ZONING BOARD OF APPEALS

401-409 West Main Street (proposed Dunkin Donuts)
Kip Finley, agent for the owner

Re: 401-409 West Main St.
Tax Parcel No. 84.006-1-4

Subject: Batavia Municipal Code: Chapter 162-12

401 W. MAIN ST.
SIGNAGE PLAN

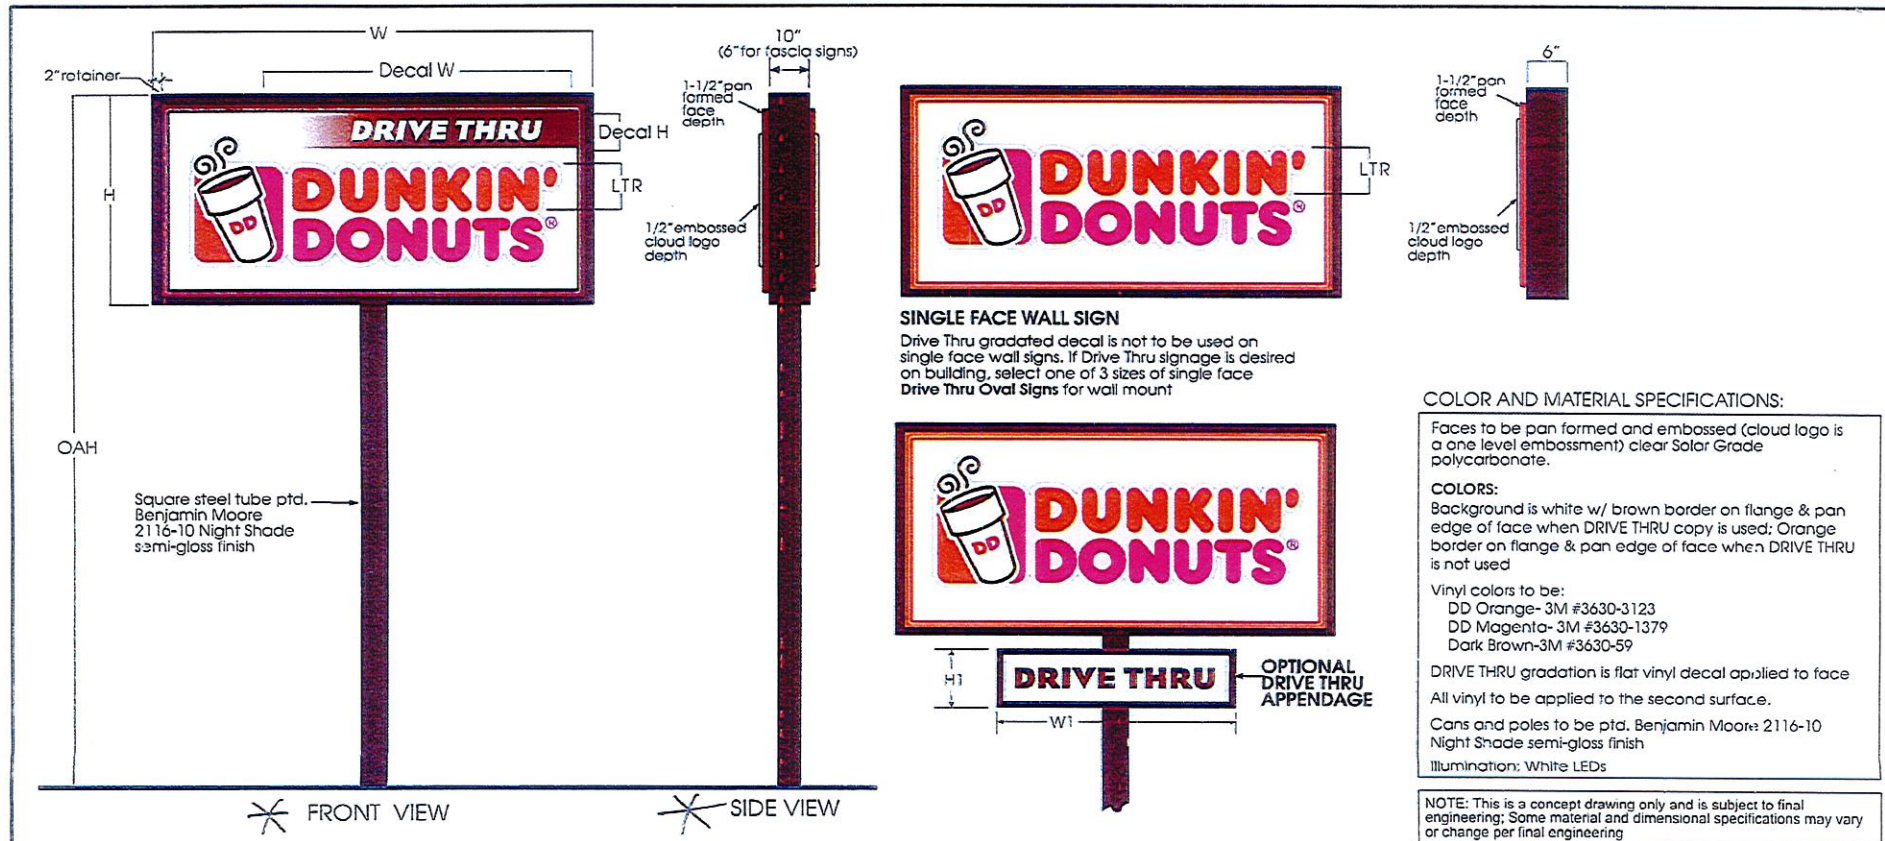
2) One free standing sign, less than 40 sq.' in area is permitted. The Dunkin pylon sign in the north yard is 80 sq.' in area.

- Free standing signs are to be located at least 5' from property lines. The Dunkin pylon sign is setback from the north property line 2'.

SITE PLAN DRAWINGS

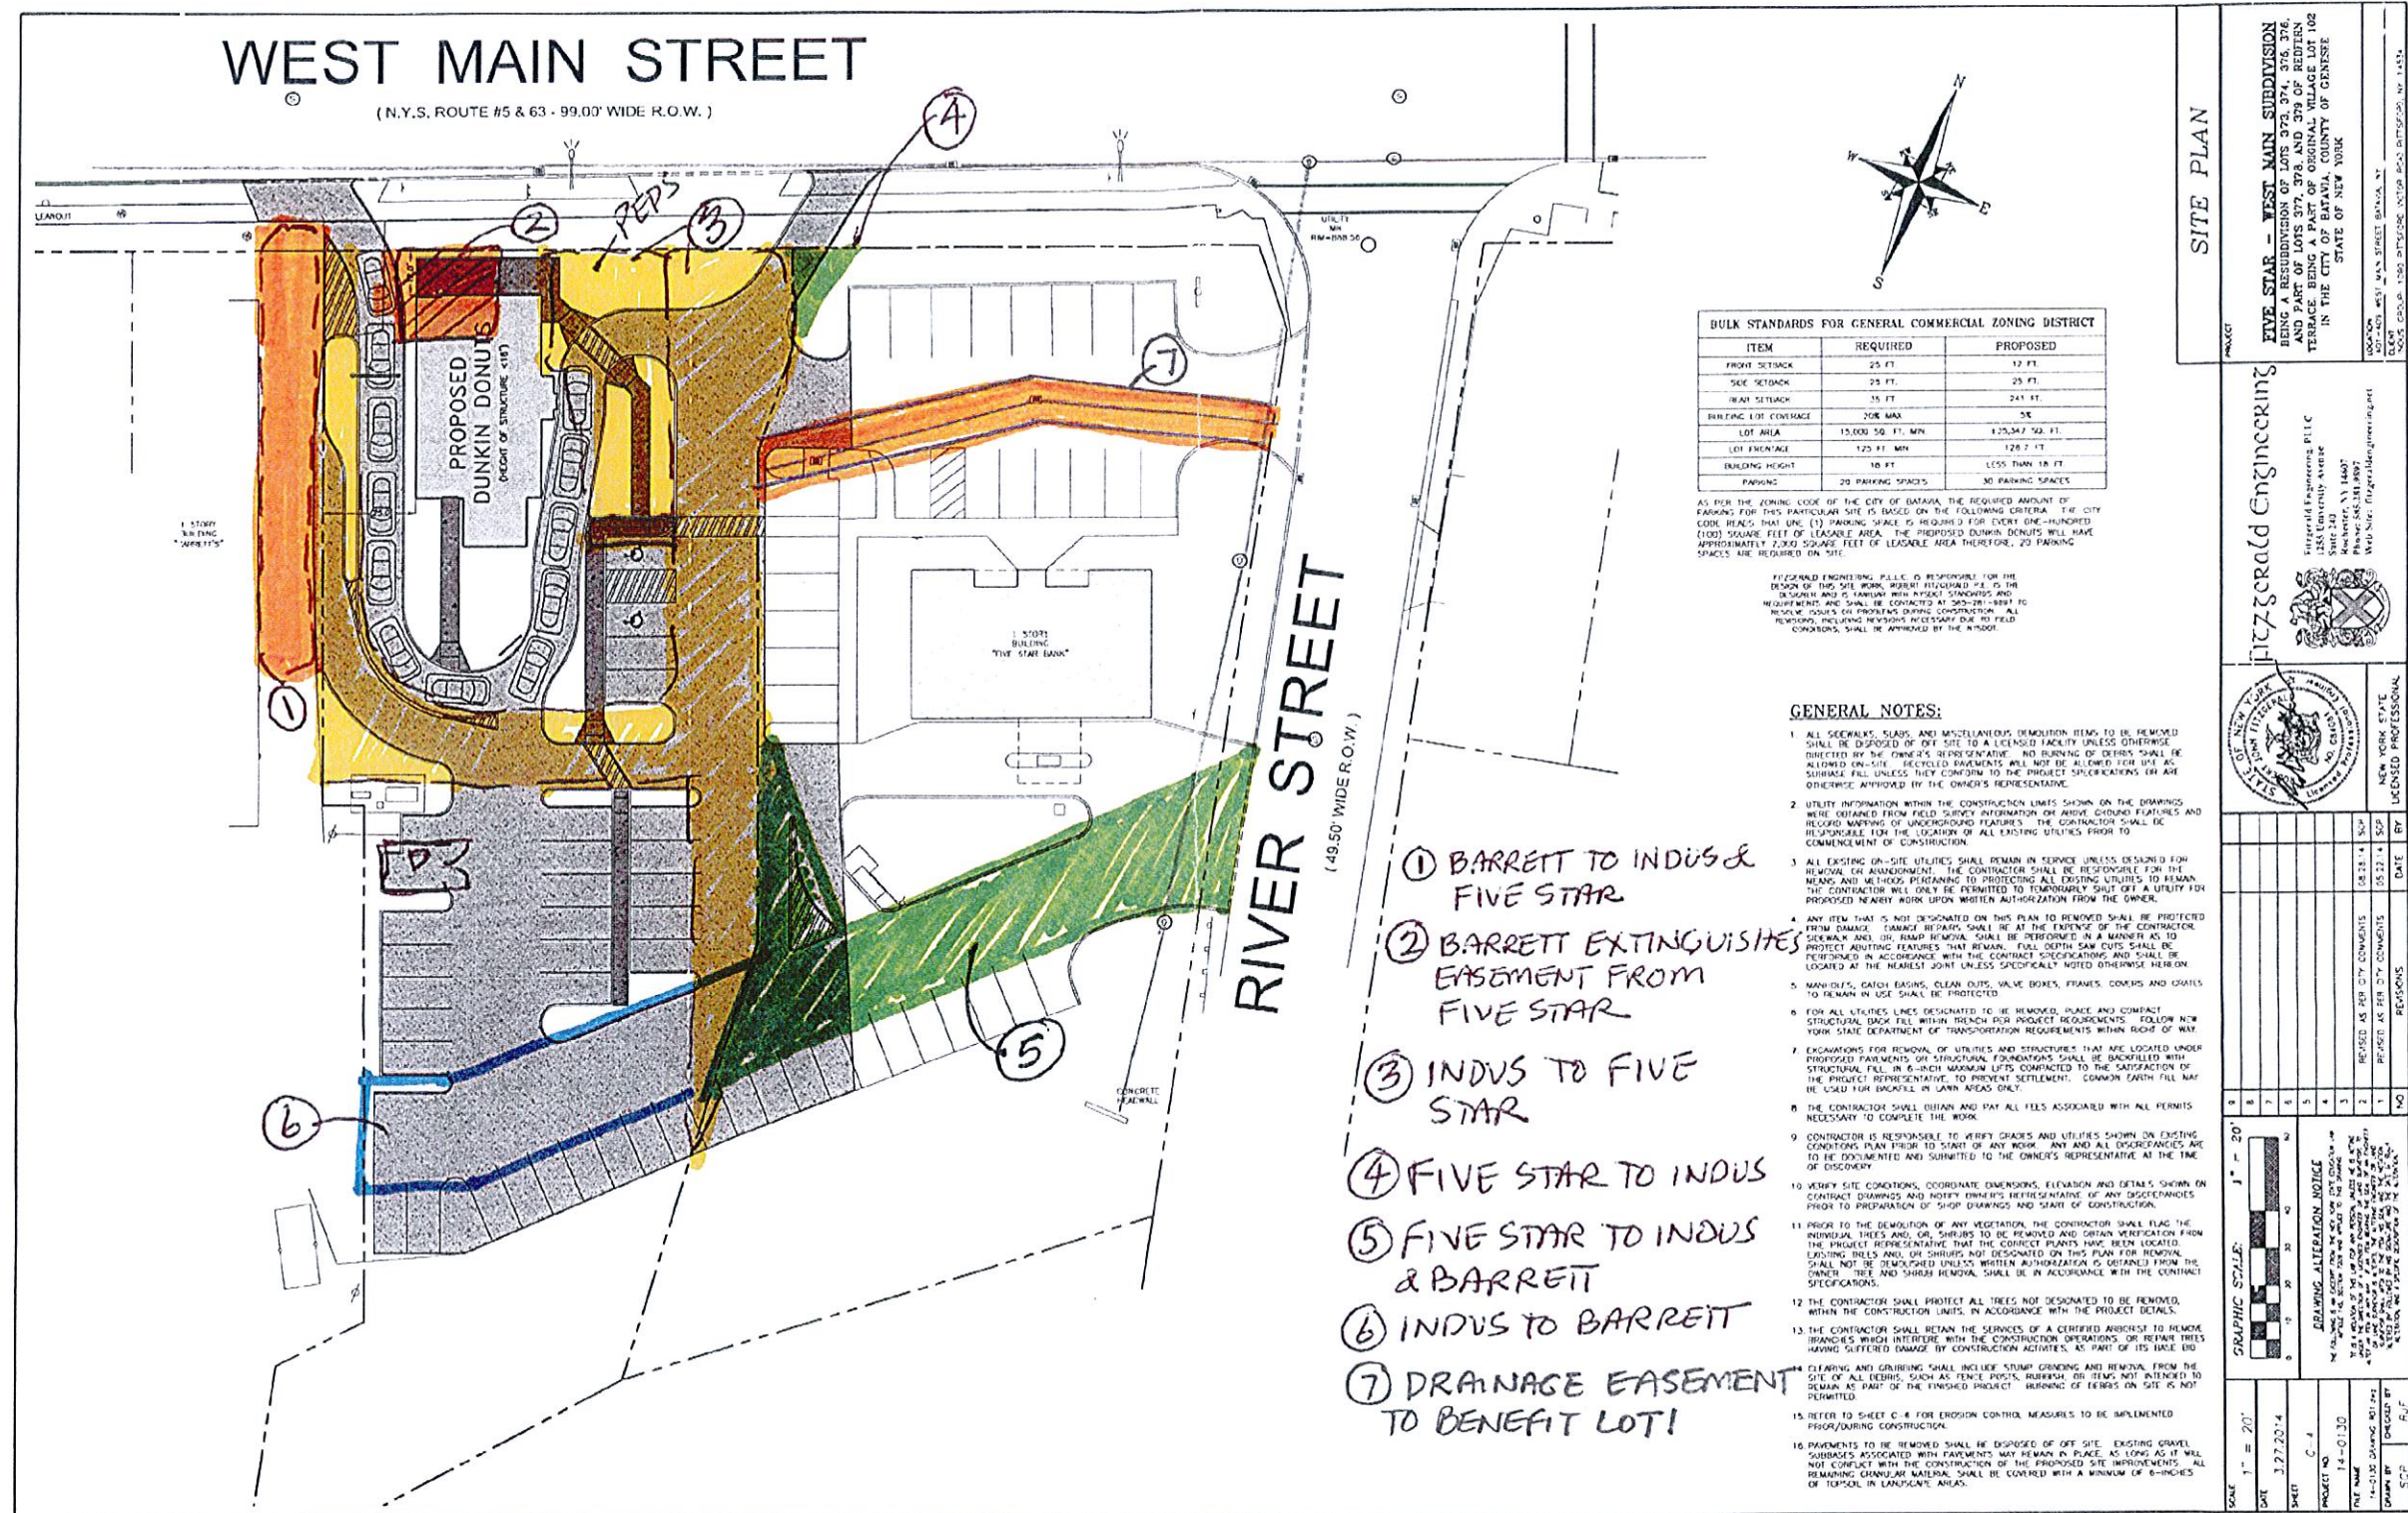
- 1) BMC 190-37 E (3) Driveways for drive-in restaurants are not permitted to be closer than 20' from side lot lines. The proposed West Main Street curb cuts, west side of parcel ingress and east side exit, driveways cross the proposed side lot lines at the street, and are on the line for the majority of the driveways length.

- 2) BMC 190-37 E (8) Parking is required at the rate of 4 spaces for each 100 sq.' of principal building space of drive-in restaurants. 88 spaces are required, 30 spaces are proposed on this parcel, difference of 58 spaces.

- 3) BMC 190-37 E. (2)(b) and 190-29 A and Schedule I The front yard clear space shall be a minimum of 25'. 12' is proposed for a difference of 13'.
- 4) BMC 190-37 E. (2)(d) and 190-29 A and Schedule I The maximum permitted height for a drive-in restaurant is 18'. 25.29' is proposed for a difference of 7.29'.

- 5) BMC 190-37 E. (3) Driveways for drive-in restaurants may not be less than 20' in width. 14' is proposed at the West Main Street exit (northeast corner of parcel). Difference of 6'.
